SUBJECT: Paint Chipping between Hood Grille (Scoop) and Hood NUMBER: 12-201-16 DATE: 06/06/16

This new bulletin replaces TSB 12-186-15 and announces a new repair procedure to address customer concerns of the hood scoop scrubbing the finish of the hood panel in the areas shown in the photo below. Due to different expansion rates between the metal hood panel and the resin material used for the hood scoop, the edges of the scoop's rear corners may come in contact with the hood panel and abrade the finish.

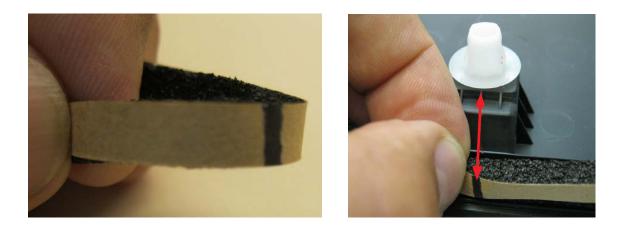
4. Using the illustrations below as a guide, clean the areas where the protectors and EPDM foam will be applied with a mild solvent on a clean shop cloth and dry completely. The illustrations and photos below show how the completed installation should appear.

- 5. Peel the adhesive backing and apply the 6 protectors to the scoop first.
- 6. The piece of EPDM foam tape in the repair kit is 1000 mm long. Locate its center point and put a mark on the adhesive backing. Align the center mark with the white scoop retaining clip as shown below.

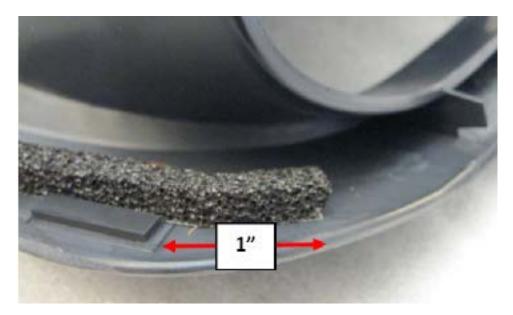
7. CAREFULLY peel the backing and working SLOWLY outward from the center point, start to apply the EPDM foam INSIDE the molded lip along the back edge of the scoop. While being careful not to stretch the foam while applying it, work the foam around the previously installed protectors as shown in the photos below.

8. When properly installed, the ends of the EPDM foam tape should appear as shown at the rear corners of the scoop, approximately 1" past the edge of the protector (right side shown below).
